# Chelan County Public Works Department

January 16, 2026  
**Addendum No. 4**  
Page 1 of 6

## RE: CRP 650, Totem Pole Road Phase I Road Improvement Project

Date 11/2025	CRP #650	CHELAN COUNTY	Drawing No. WP1	
11/2025		TOTEM POLE ROAD PHASE 1	Sheet No. 30 / 50 of Total	
11/2025	Project Number 20220011	RETAINING WALL PLAN AND PROFILE		
11/2025

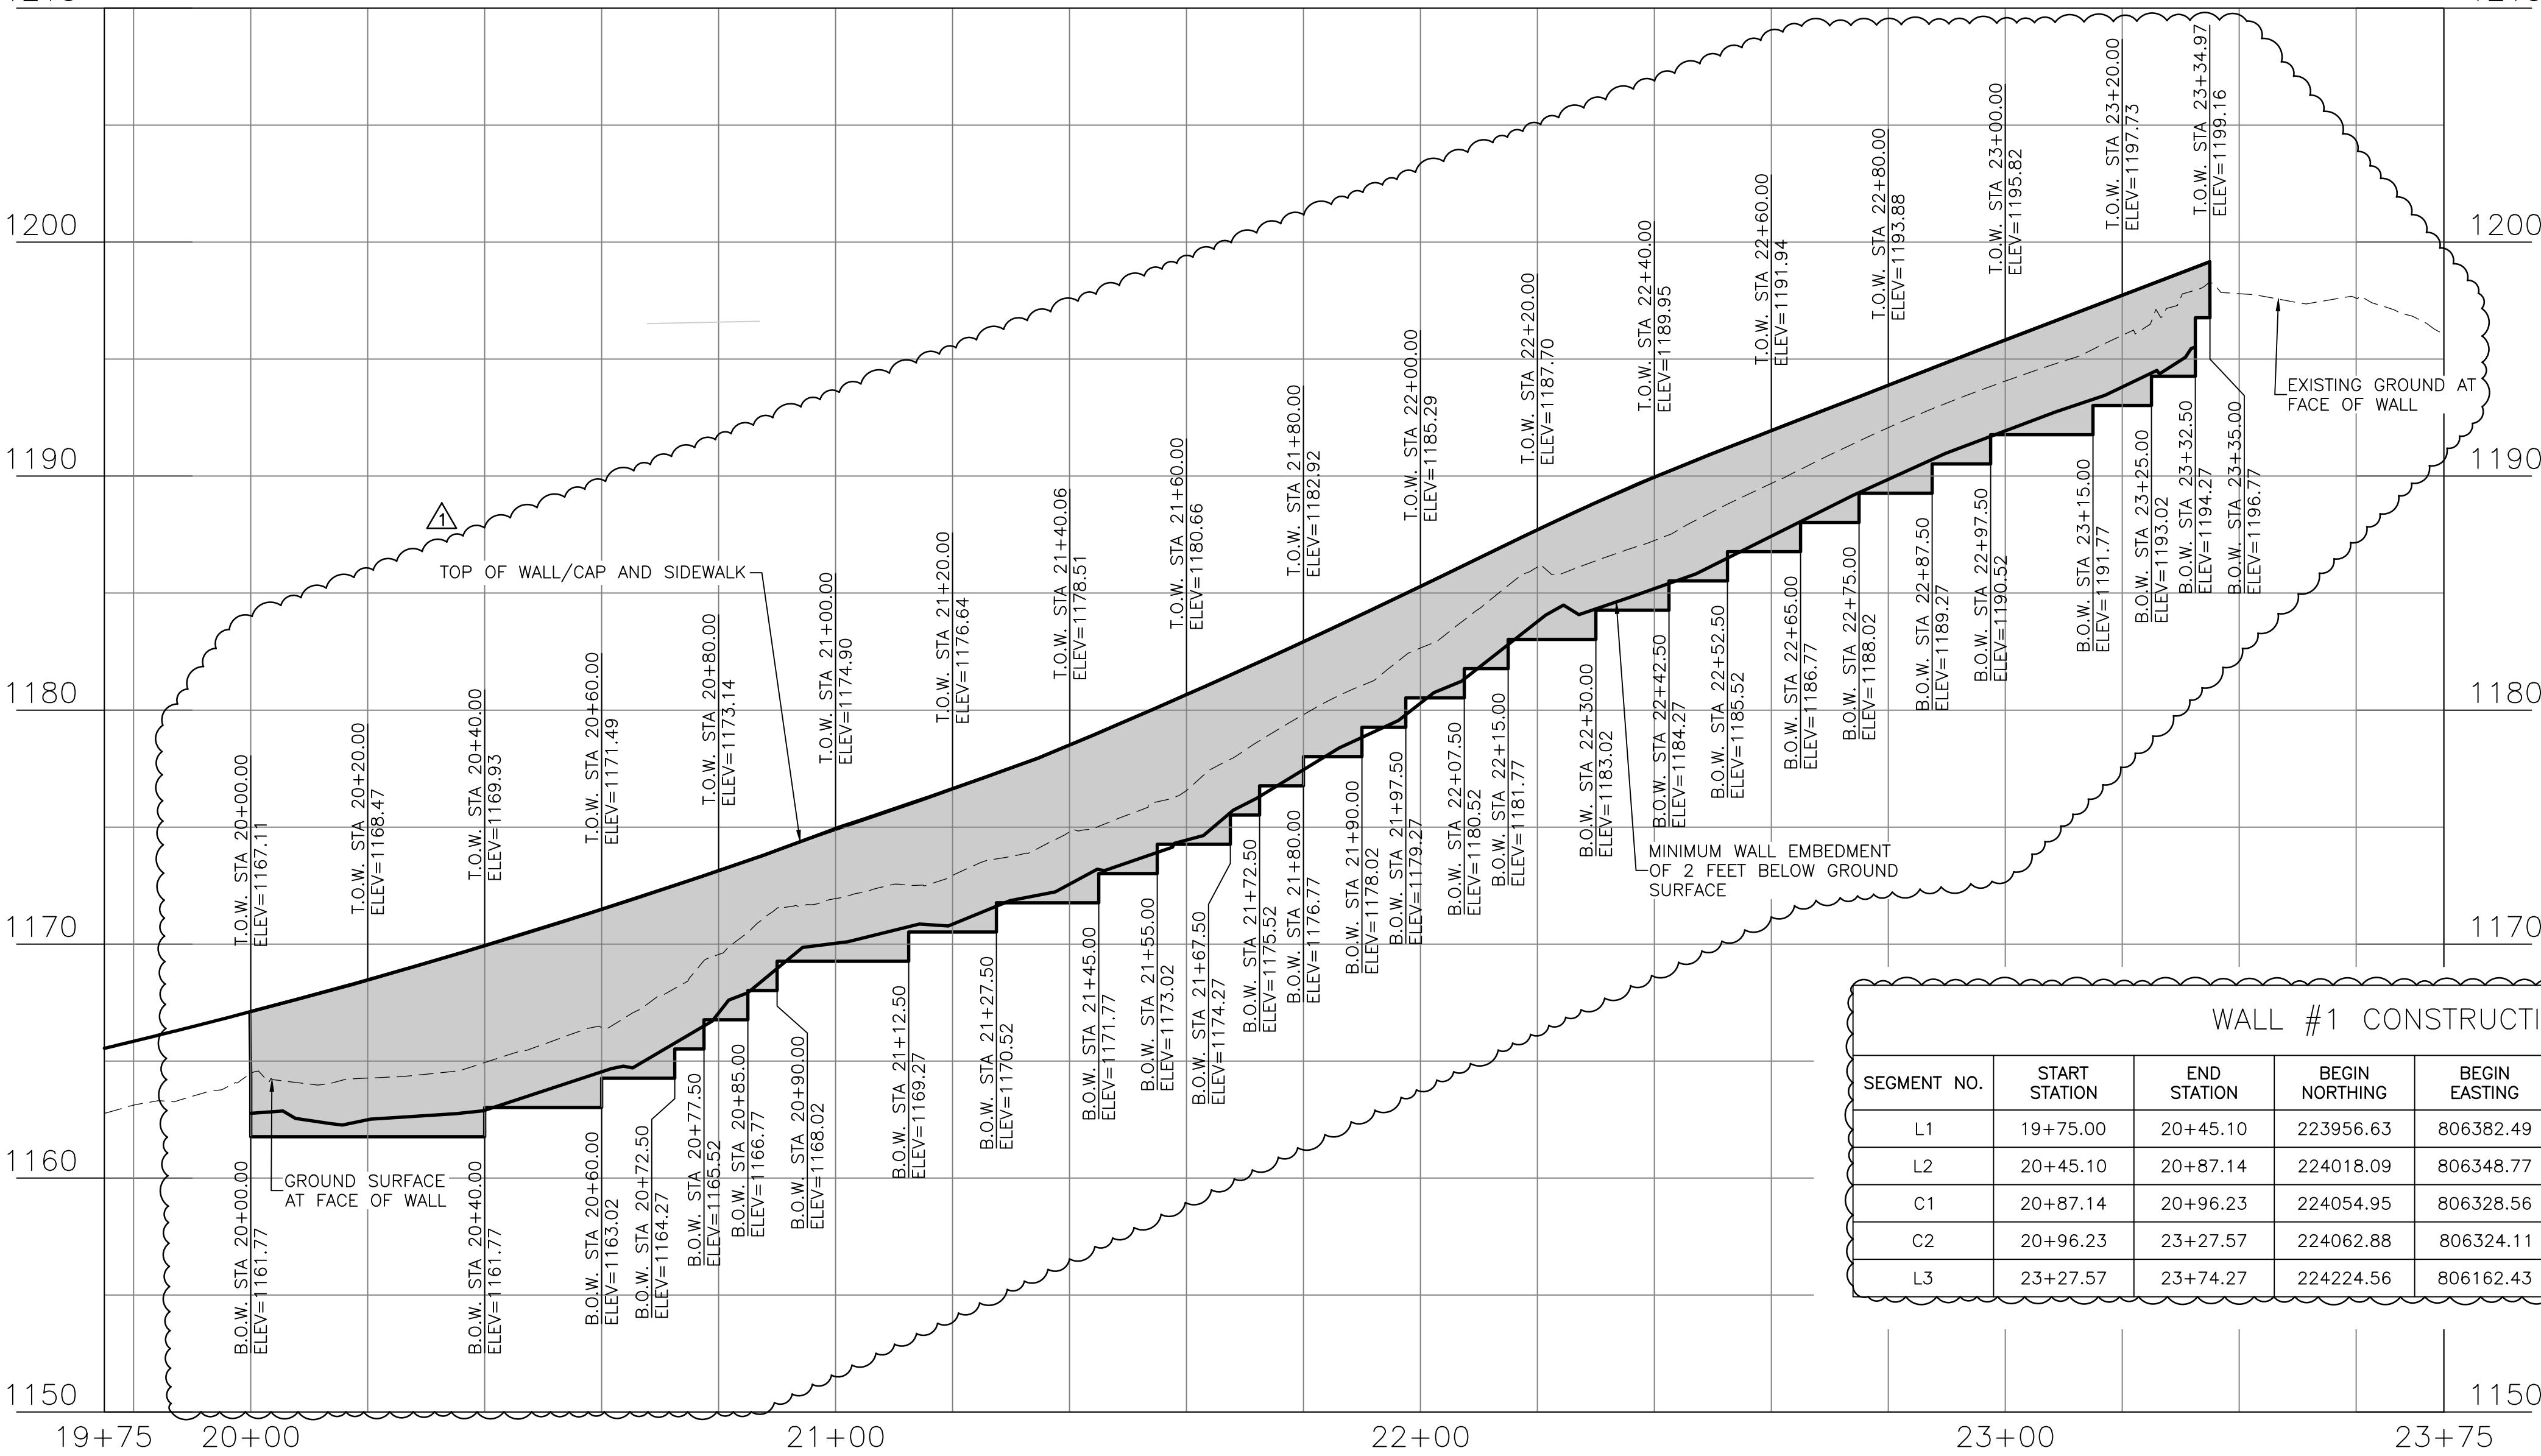
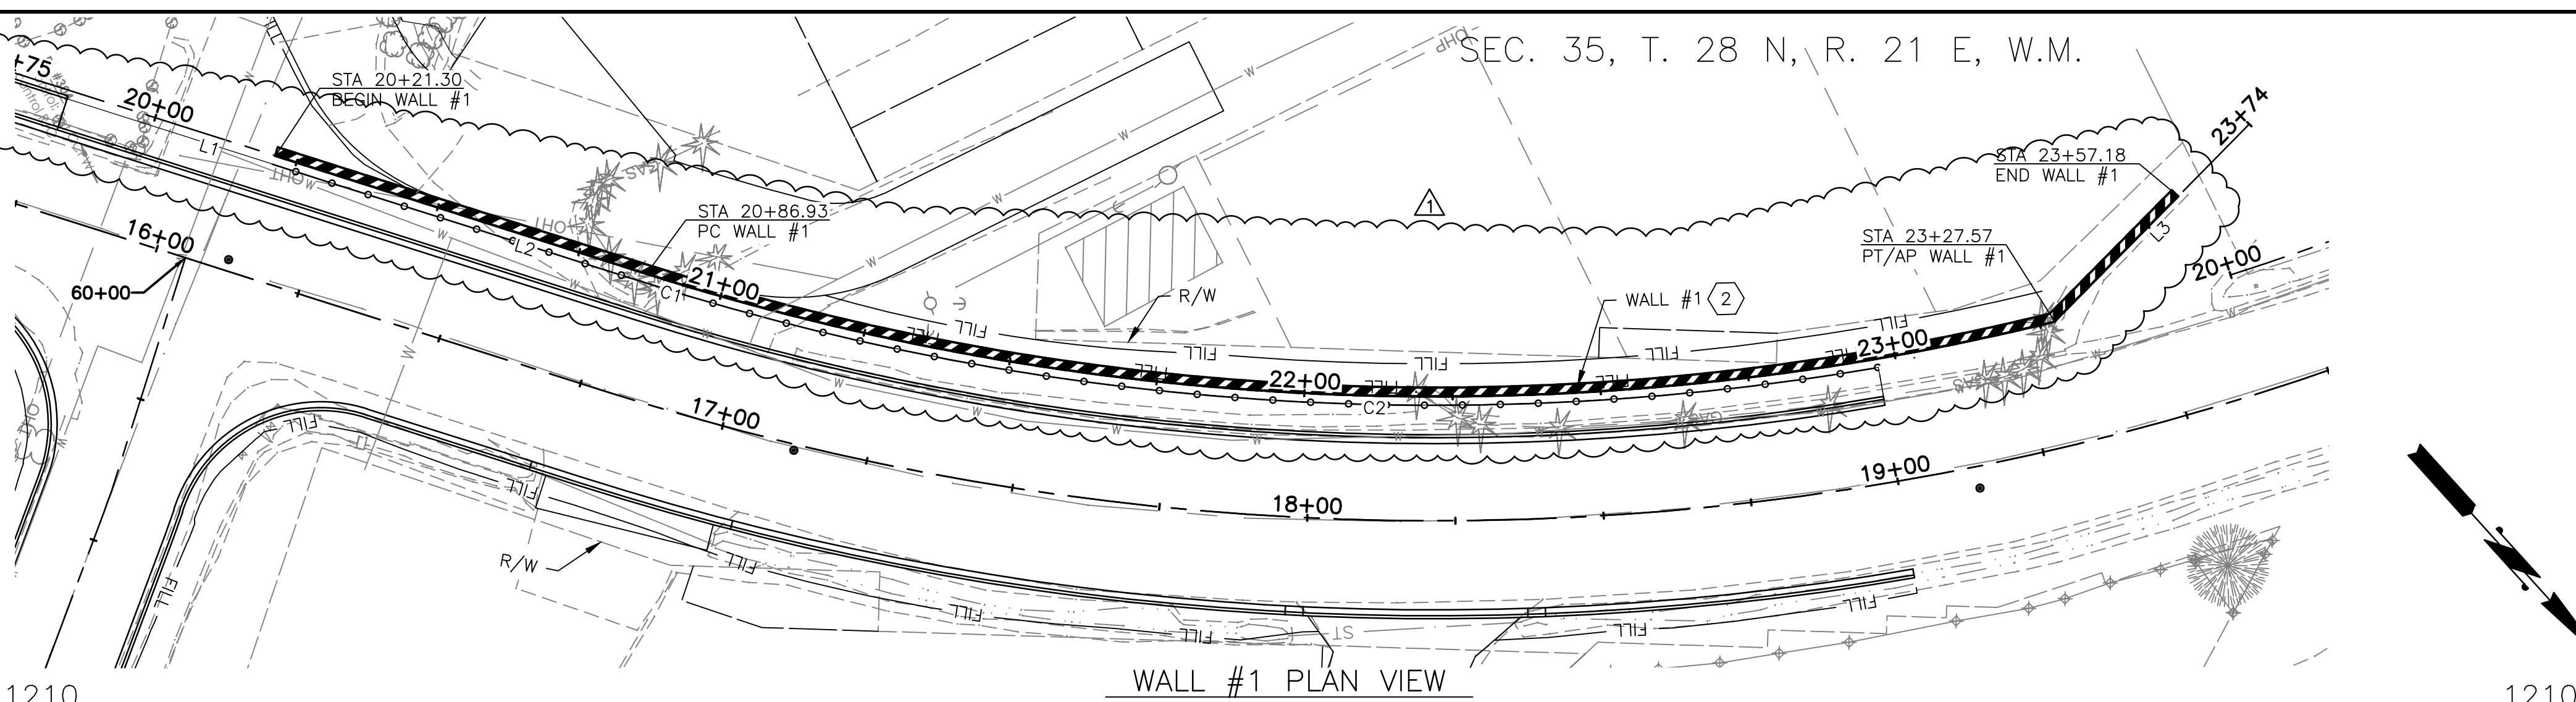
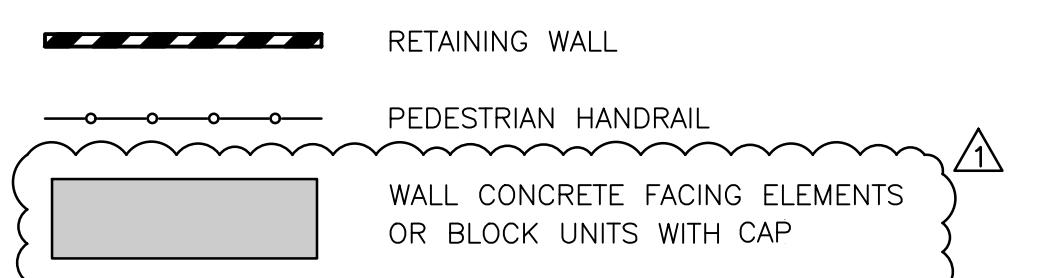
1. Remove the following plan sheets and replace in their entirety with attached Addendum No. 3 Plan Sheets:

WP1 (Supersedes note change from Addendum 1), WD1, MD1

1. Question: Multiple Contractors and Suppliers asked for clarification regarding retaining wall type, retaining wall cap, and mounting the pedestrian railing to Wall #1. Additionally, Contractors requested an alignment for Wall #1.

Answer: See included changes to Special Provisions and attached, revised, Plan Sheets for clarifications.
